Notice of Intent

Sundry ID: 2778457

Type of Action: APD Change

**Procedure Description:** OXY USA Inc. respectfully requests approval to amend the subject well(s) AAPD to update the production string cement from 13.2ppg Class H/Poz slurry to a 13.3 Class C/Poz slurry. See the attached drill plan revision summaries and lab test for reference. No surface hole changes or additional disturbance are related to this sundry.

**UCA Compressive Strength**

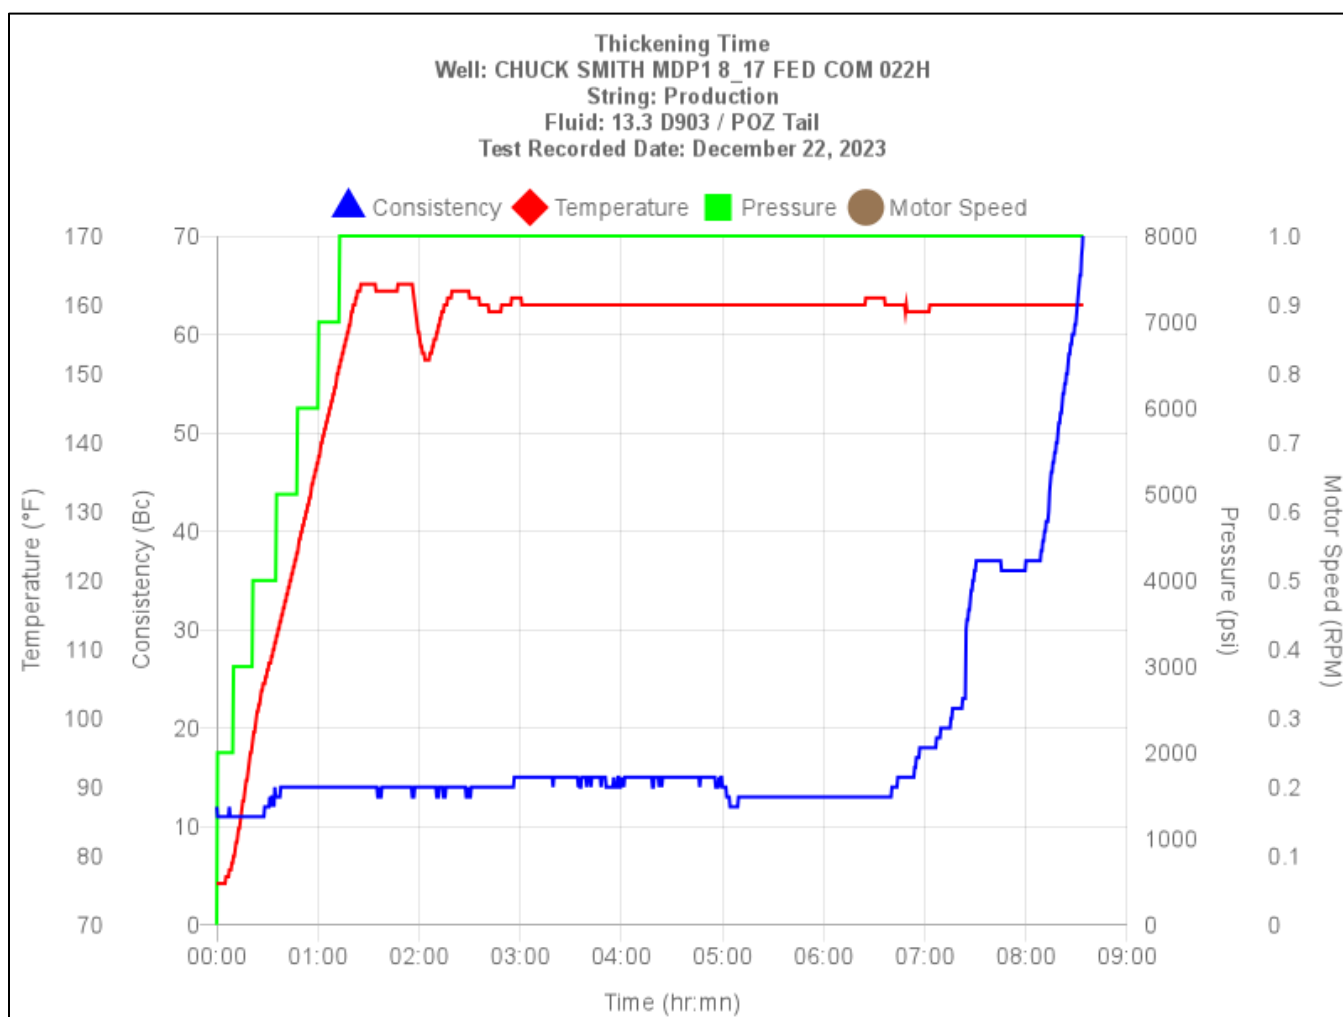
Note: When compared to the Class H / Poz system(s), the Class C / Poz slurry achieved earlier (faster) compressive strength development.

Class H / Poz: 500 psi 13:12 hr:mn

Class C / Poz: 500 psi 06:10 hr:mn

Time	Compressive Strength	Temperature
03:58 hr:mn	50 psi	160 degF
06:10 hr:mn	500 psi	160 degF
24:00 hr:mn	1069 psi	160 degF
48:00 hr:mn	1241 psi	160 degF
72:00 hr:mn	1294 psi	160 degF
Machine S/N:	640
